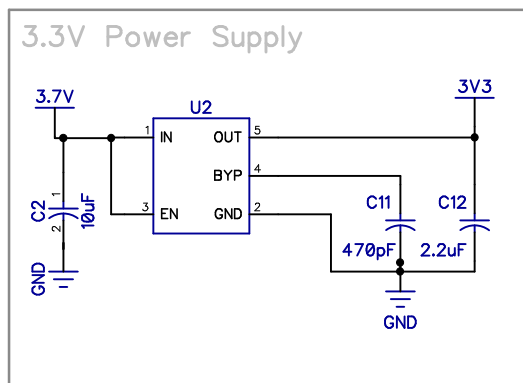
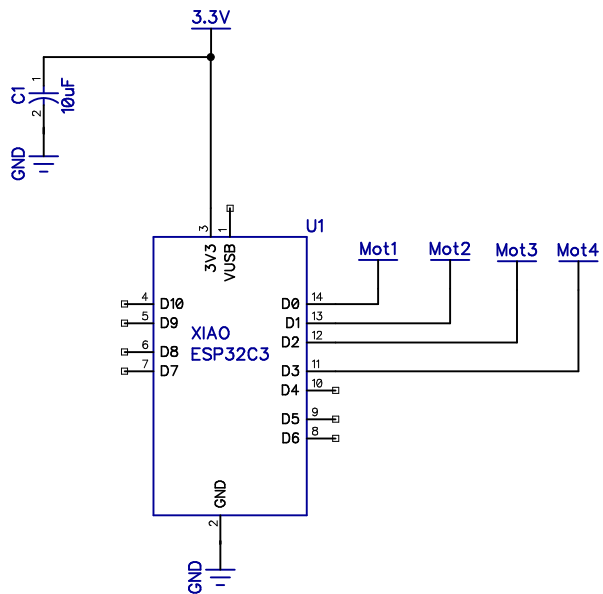
Need to change to a more efficient LDO

Need to Add ICM20948 IMU (or change if necessary)

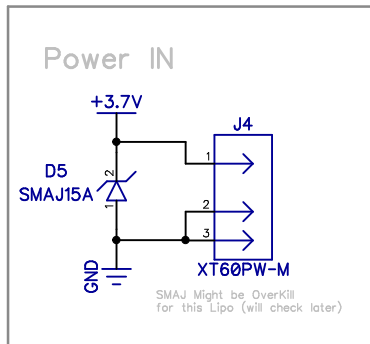
Also need to check on better connectors
As the one currently selected is too big
